My Ref: D1760AIAL1

**RE: 200 PARK AVENUE, PURBROOK PO7 5EZ
PROPOSED DEVELOPMENT**

I have now visited the above site and collected relevant tree information and a copy of the tree schedule to BS 5837:2012 is attached. I have marked the R&R Design Studio 'Proposed Drainage and Location Plan', drawing number 1001-101 Revisions A dated 30.10.2014 with tree numbers and a copy of the annotated plan is attached as plan AC1. My preliminary observations are set out below.

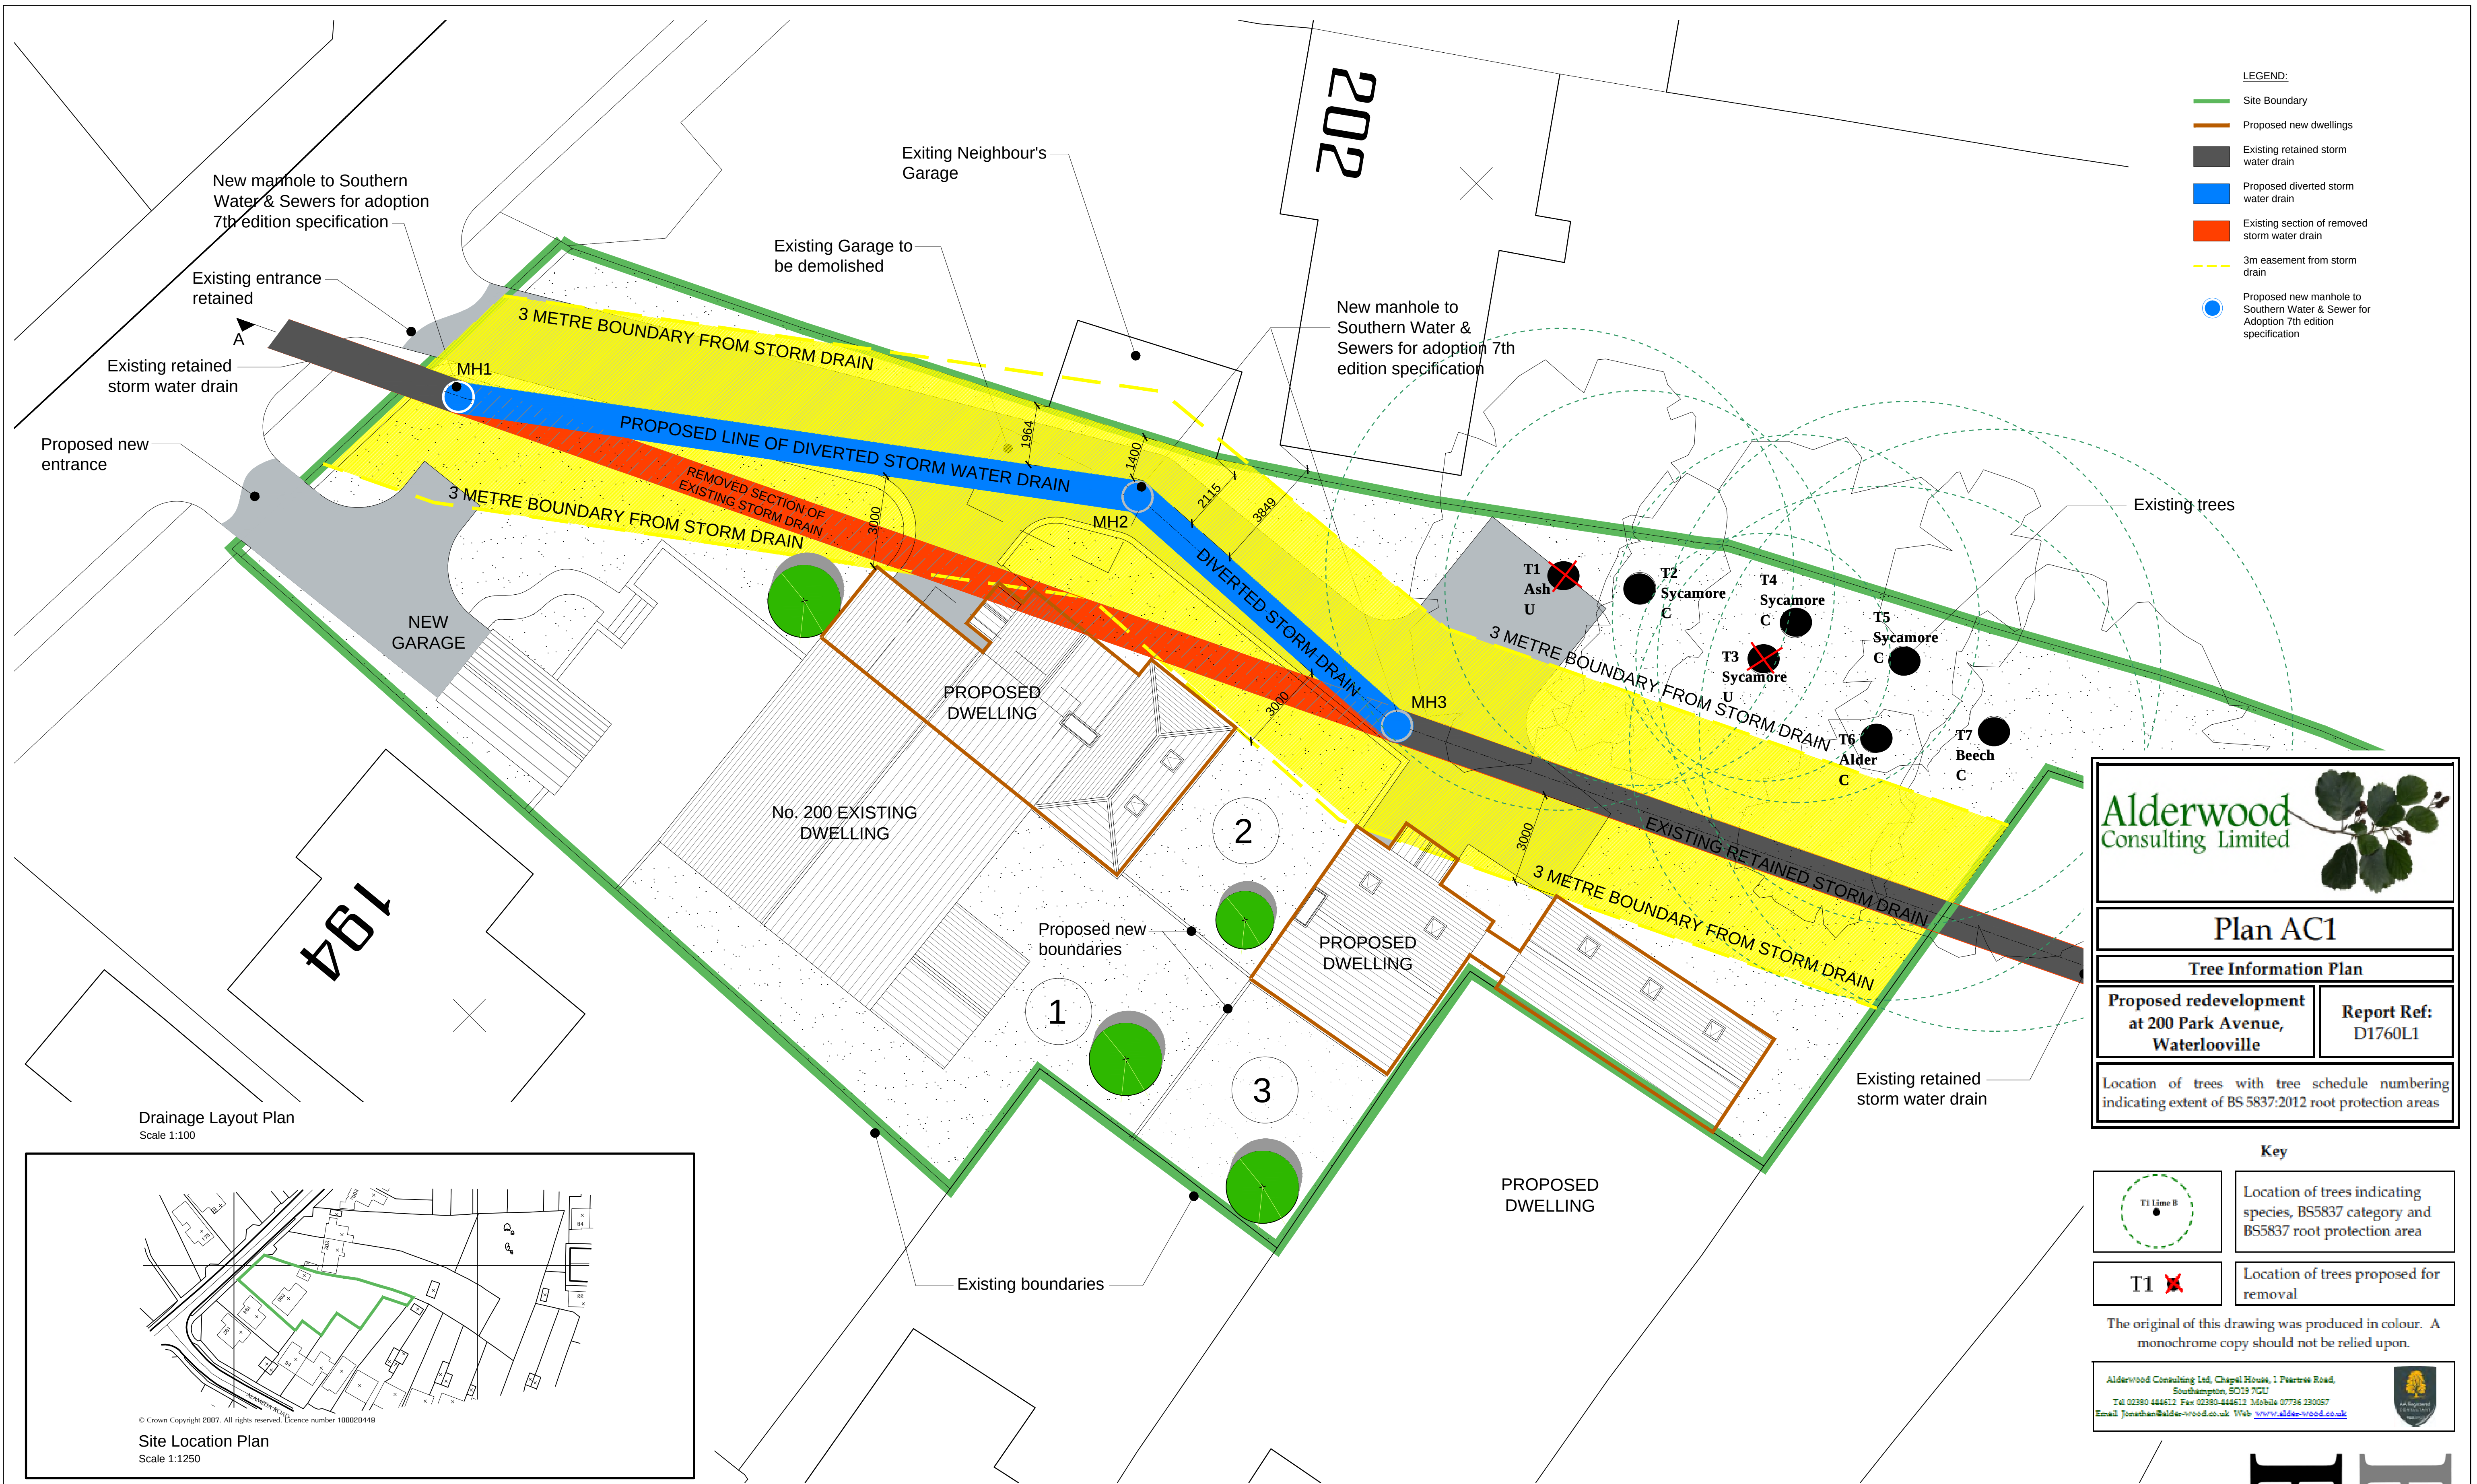
Root protection areas: The area of root protection should be equivalent to the area of a circle centred on the tree with a radius of least 12 times the trunk diameter. The radius is given in the last column of the tree schedule and is based on measured trunk diameters. I have marked root protection areas on the plan AC1.

Services and easement: The plan AC1 indicates the line of the existing storm drain, with proposals for its realignment. Depending on the comparative ages of the drain and the trees, there may have been excavations within root protection areas for the installation of the drain. In any event, and whether the Ash T1 is removed or not, it would be reasonably practicable to run the realigned storm drain through part of the root protection area of T1, given that its rooting requirements have been so significantly reduced by the consented pruning.

TPO tree work application: Typically, the Local Planning Authority would look for propose tree works to be specified; and for the reasons for the works to be set out clearly. This letter has been prepared with a TPO tree work application in mind, and it may be submitted together with the tree schedule and plan AC1 with an application, in support of the proposals.
